02-205661

# PERMIT

SEWAGE DISPOSAL SYSTEM  
HOWARD COUNTY HEALTH DEPARTMENT  
BUREAU OF ENVIRONMENTAL HEALTH  
410-313-2640

SUBDIVISION Lyndonbrook LOT NUMBER 5 ADDRESS 2070 St James Road

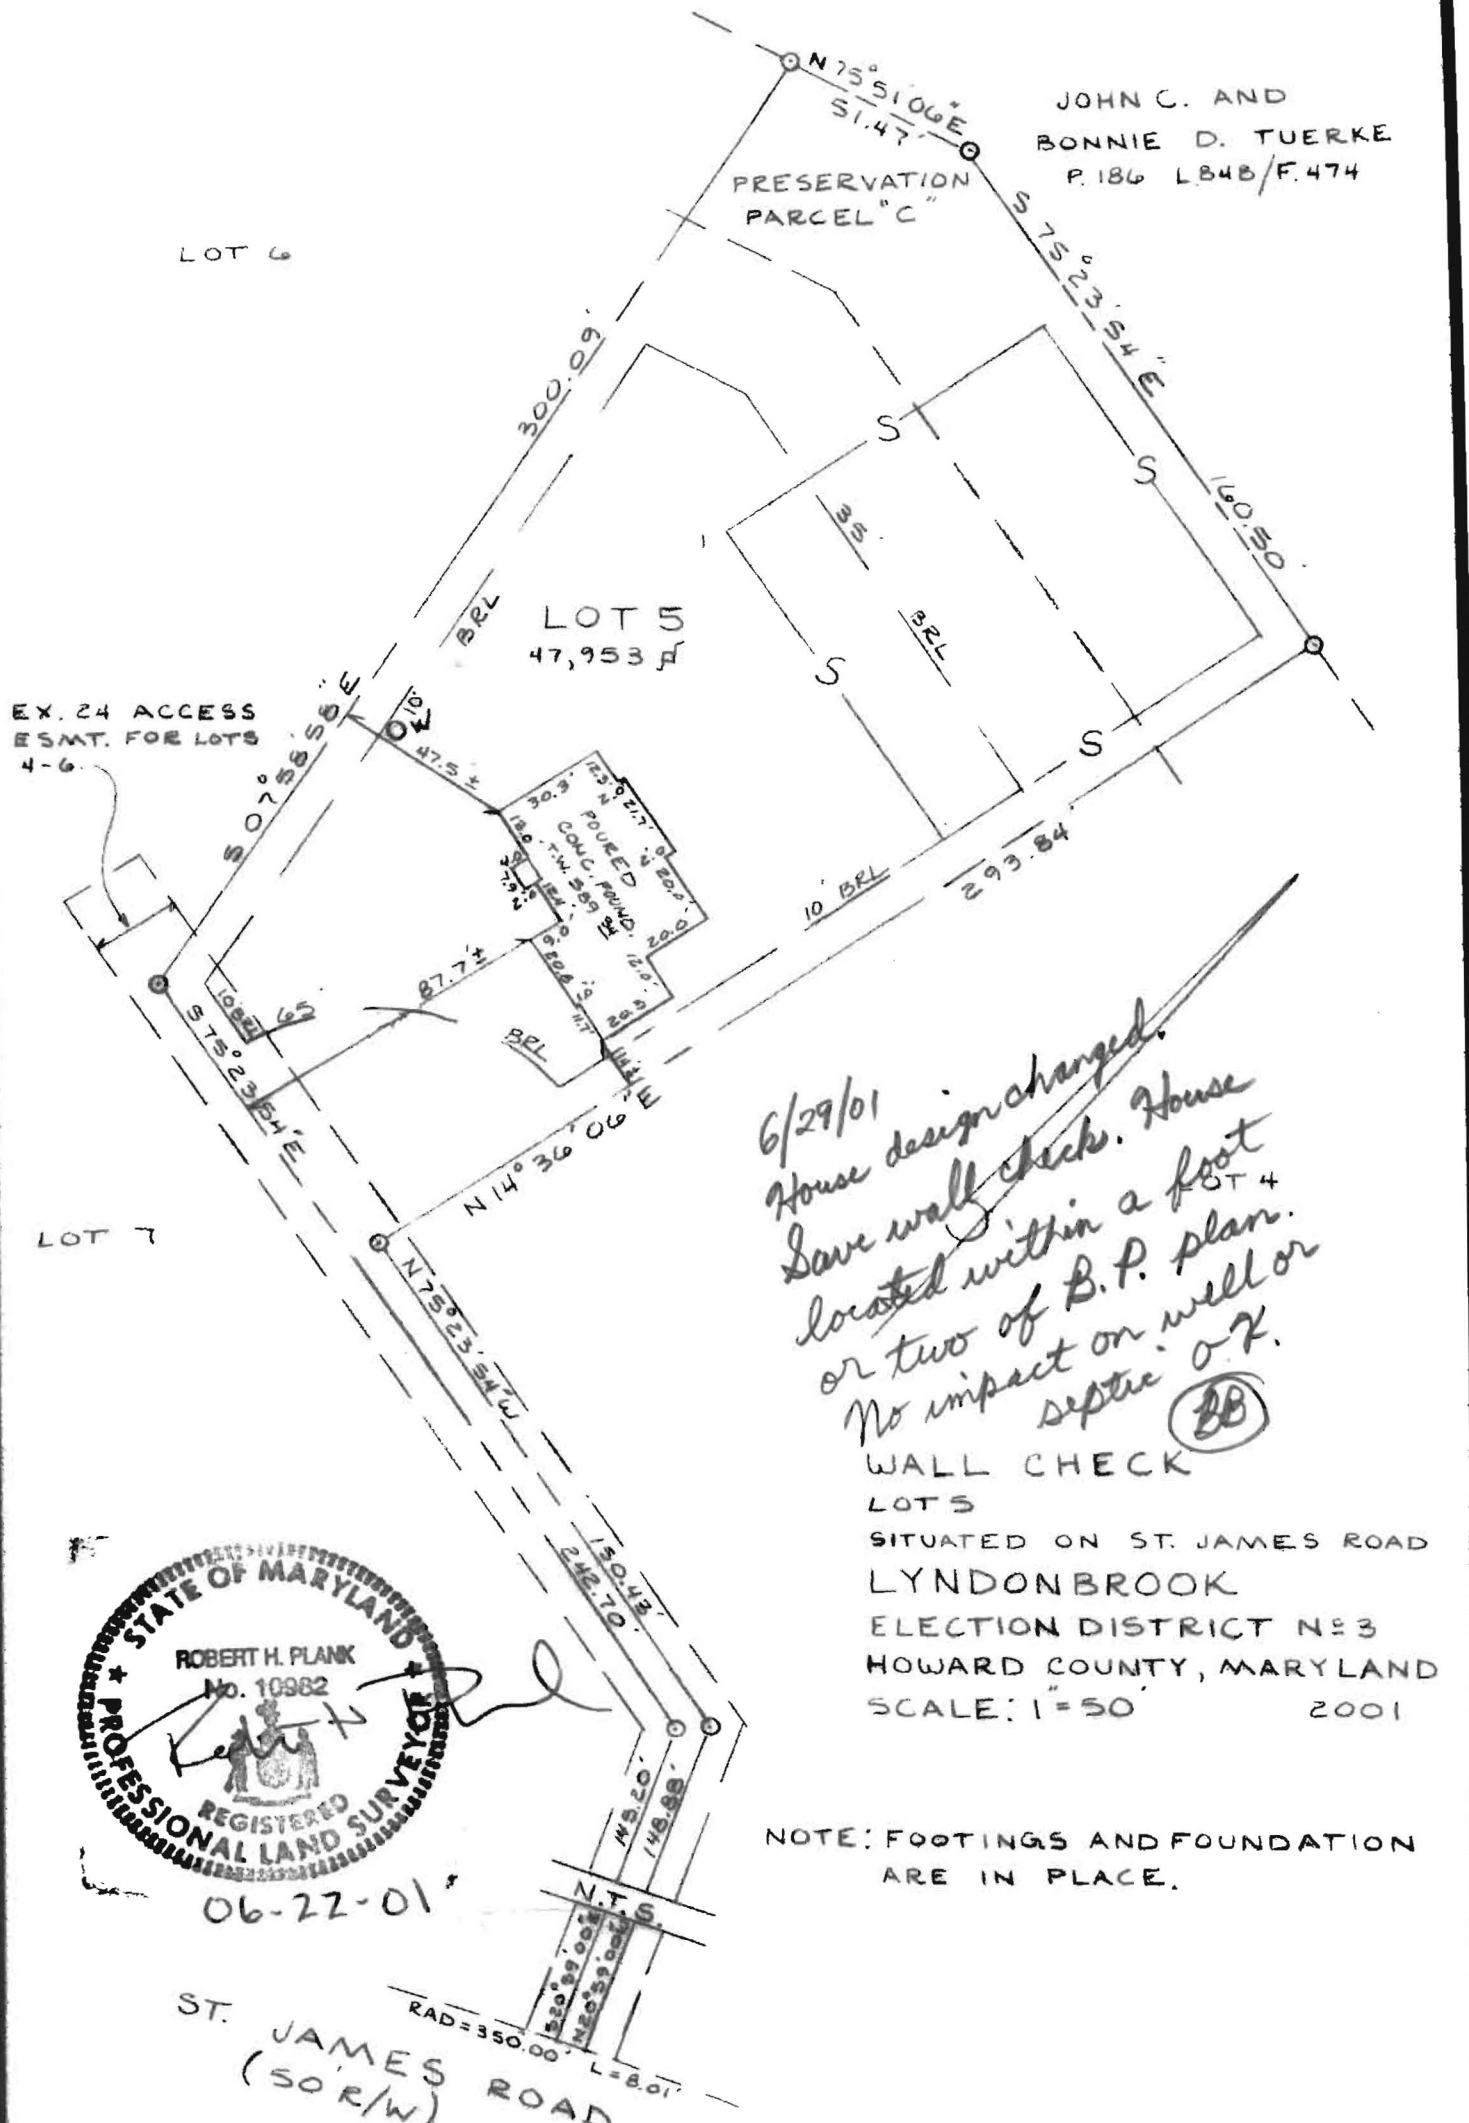
PRE-CONSTRUCTION INSPECTION: 7/23/01 SDA not staked - tank not set - informed installer that SDA must be staked to

INSPECTION COMMENTS: 7/31/01 - OK TO COVER ALL WORK, DISTRIBUTION BOX & TRENCHES COULD  
 INSTALLED IN LOWER PORTION OF SDA BECAUSE BUILDER'S PEOPLE CLEARED TREES IN THAT AREA INSTEAD OF IN THE UPPER PORTION, GRAVITY FLOW TO UPPER <sup>2</sup>/<sub>3</sub> OF SDA STILL POSSIBLE - SO OK PER (ALM) <sup>SRK</sup> HOUSE CONN. STILL NEEDED - (SRK)  
12/4/01 - HOUSE CONN. VERIFIED TO HAVE BEEN MADE BY BUILDER - (SRK)
